**FINAL MITIGATION PLAN**  
**MIDDENDORF SPRINGS MITIGATION SITE**  
**ANSON COUNTY, NORTH CAROLINA**

DMS Project No.100151  
DWR Project No. 2020-0775v1  
NCDEQ Contract No. 8012-01  
USACE Action ID No. SAW-2021-01973

Re: NCIRT Review and USACE Approval of the NCDMS Middendorf Springs Mitigation Site /  
Anson County

Re: DMS Project ID # 100151 / Middendorf Springs Stream and Wetland Mitigation Site Mitigation Plan  
IRT Comments

C-5

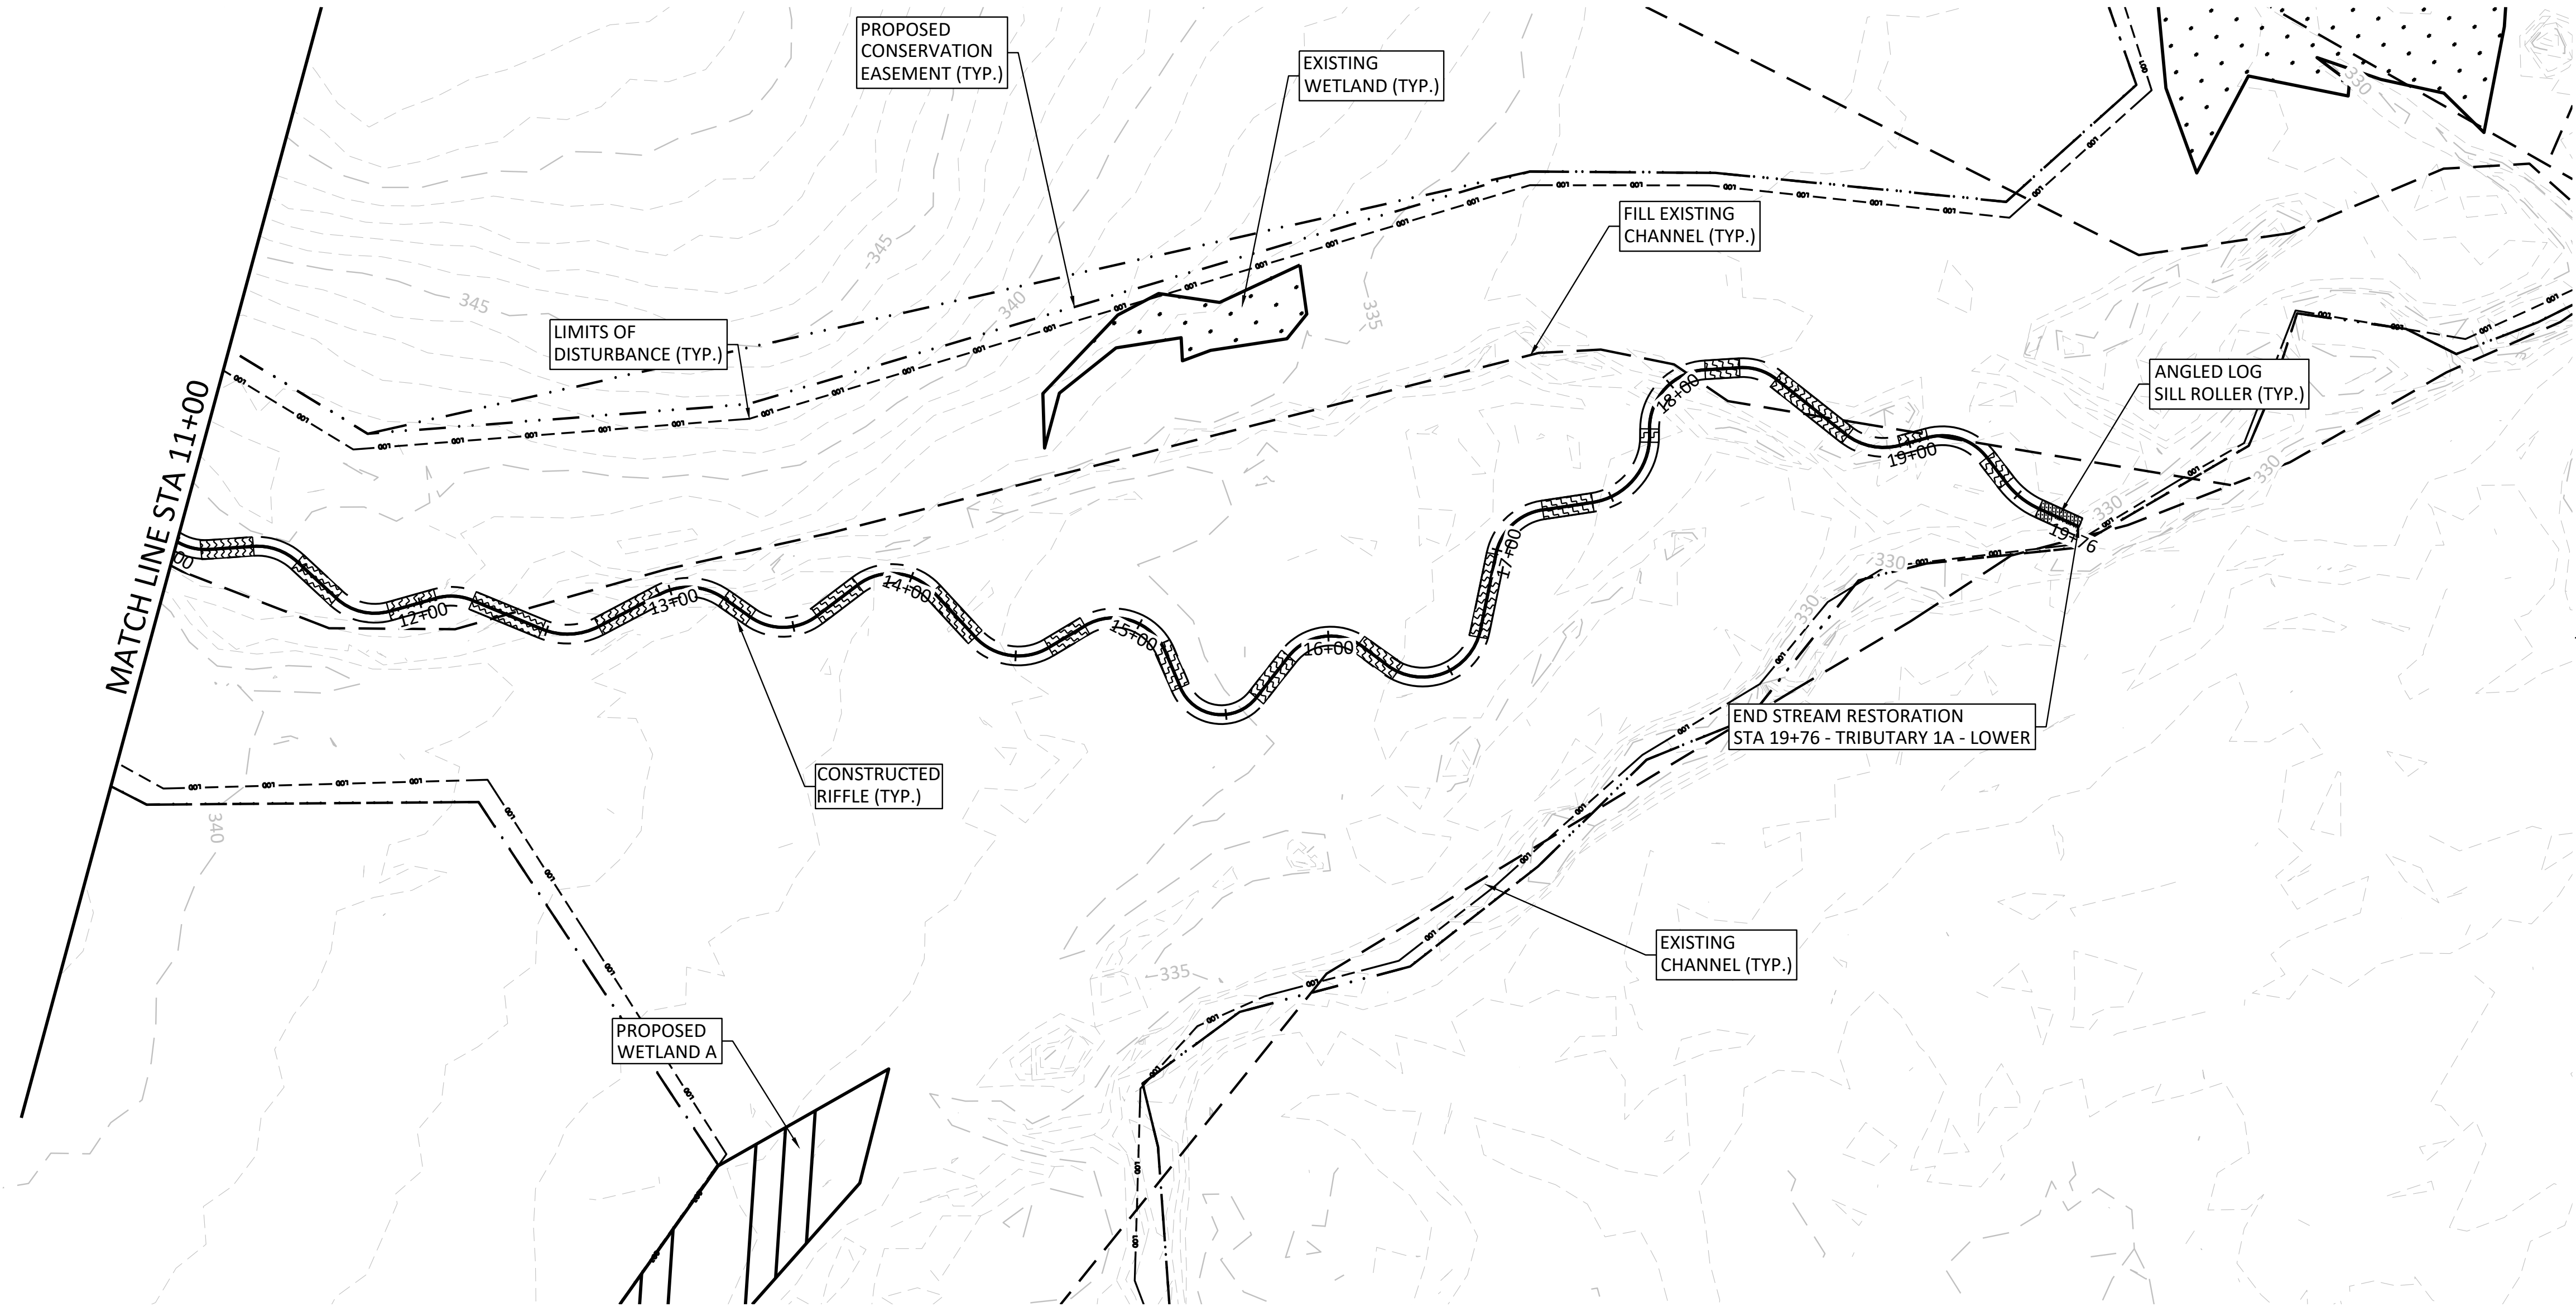
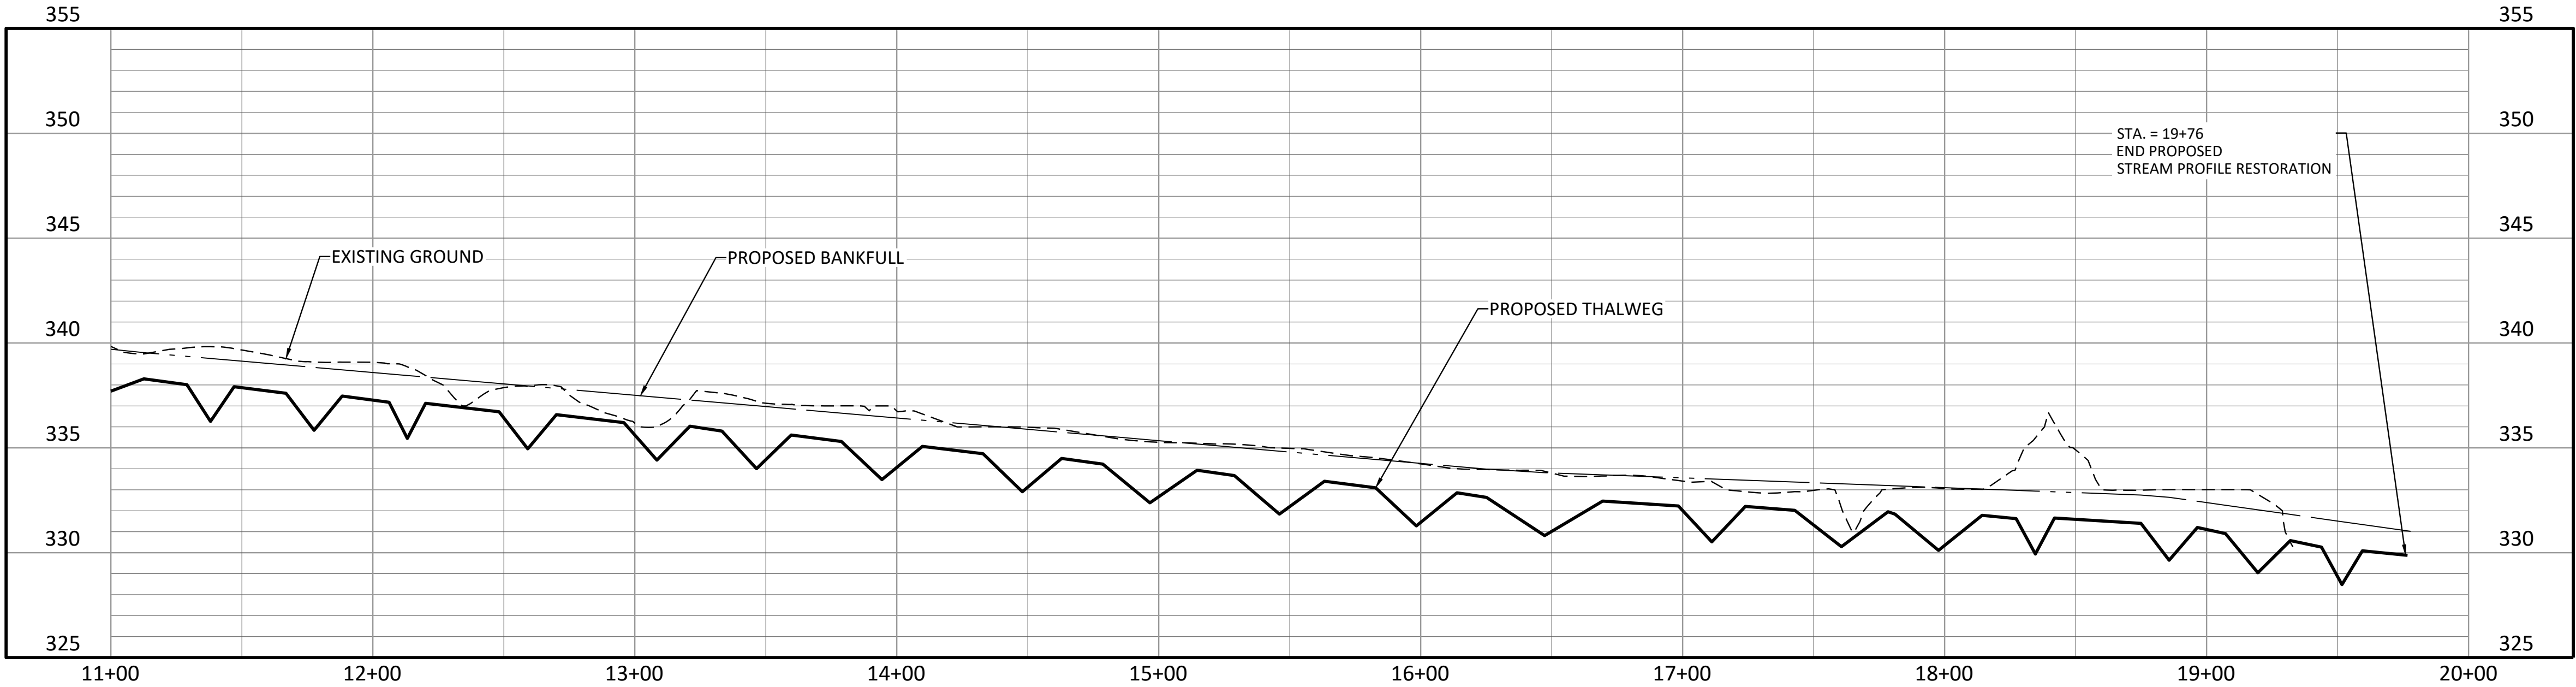
- 12. Design sheet- C5 - DWR requires a wetland gauge stream right near station 2+50. This section shows a lot of constructed riffles. DWR would like to emphasize their concern of placing rip rap in the stream channel. DWR suggests the designer look for a source of rock on site that more resembles native rock on site both in type and in size for the stream. In addition, DWR noted that there does not appear to be any bank treatments for the meander bends. How does the designer intend to maintain the stability of the stream in these areas (Design sheet C6)?**

***Sheet C-5:*** Please include culvert/crossing information on this page. Please also include a detail for the proposed crossing/culvert.

Comment noted with respect to the gauge and this will be added to the mitigation plan.

See response to DWR Comment #6 regarding rock selection for the constructed riffle section.

With respect to the meander bend question, we ask that the commenter consider the size of the stream channel that is proposed. Based on our calculations, shear stress on the outside bend is not high. The site's drainages are small channels, and the installation of a bank stabilization treatment like toe wood or similar treatment would be very large considering the channel size and overwhelm the small channel, potentially affecting the pool size and function and creating instability issues rather than helping with stability. However, to address concerns over the stability of the meander bends we will increase the planting density on the banks.

C-9

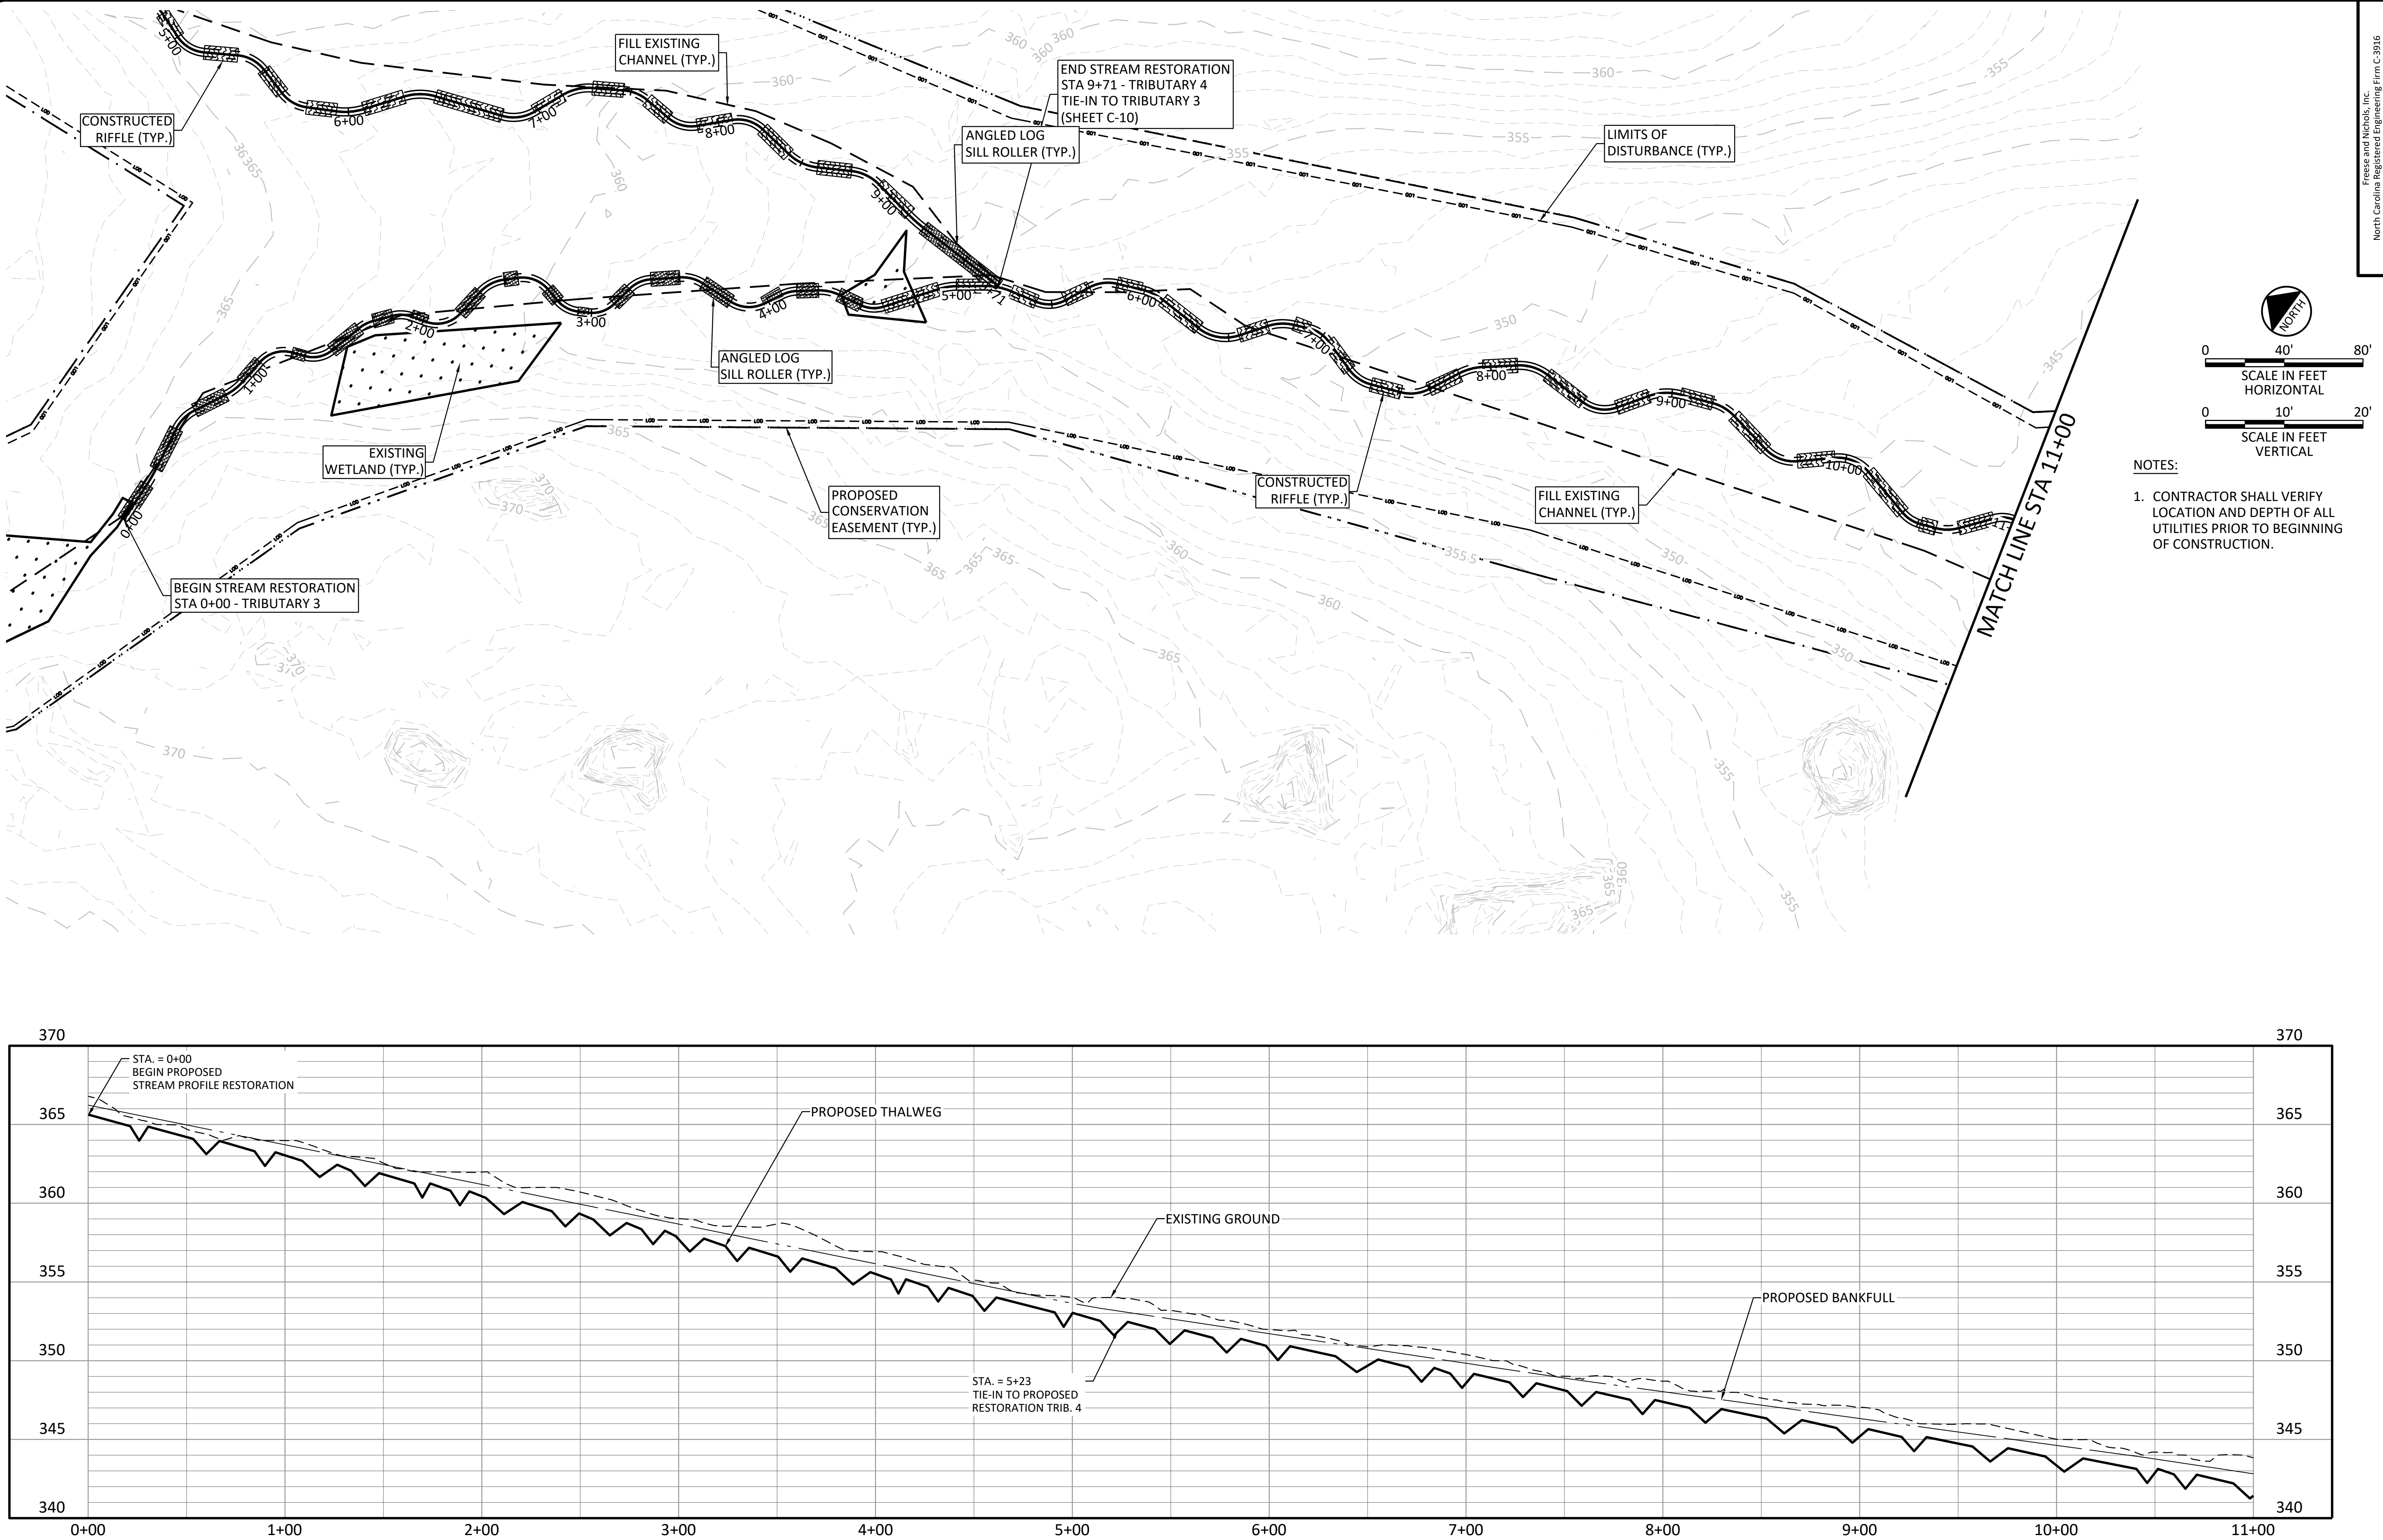
- 14. Design sheet C9- in the longitudinal plot there were no lines.**

We checked Sheet C-9 in the PDF version and the longitudinal plot lines are showing up correctly. It is possible that if you were reviewing a hardcopy that the lines may have printed out too faint to see. We will double check the plot hardcopy and adjust as necessary to make sure the lines are showing up.
